ABWR

Subject ABWR PRA CONSEQUENCE ANALYSIS

Message The updated analysis follows.
Section 10E.3 will be updated
to reflect these results.

ABWR PRA CONSEQUENCE ANALYSIS

Figure 1-1 Whole Body Dose at 1/2 Mile
as a Probability of Exceedence

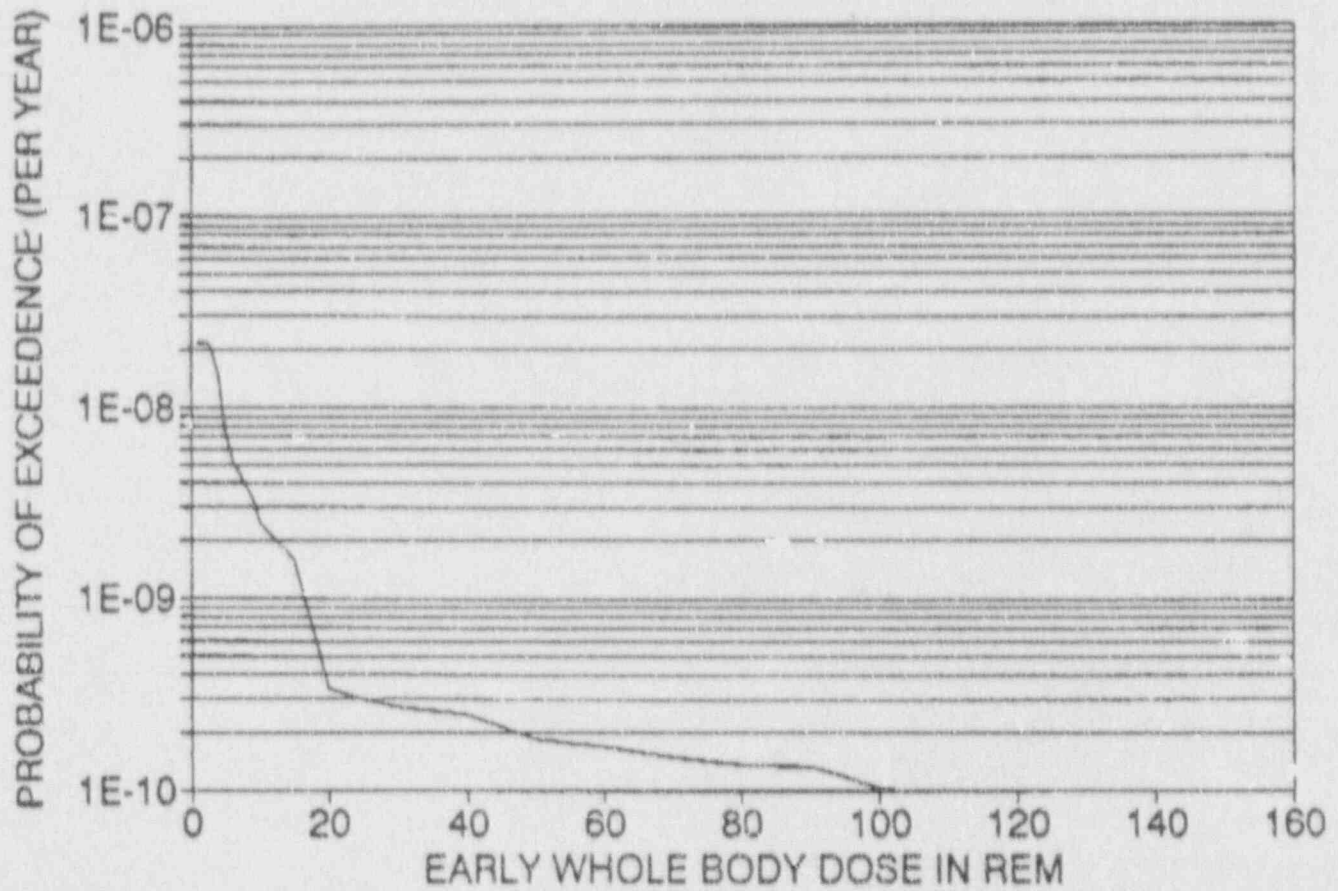
The probability of exceeding various dose levels as a function of dose is shown in Figure 1-1 which will replace amendment 8 Figure 19E.3-1. The goal of not exceeding 25 Rem at 10^{-6} probability is achieved.
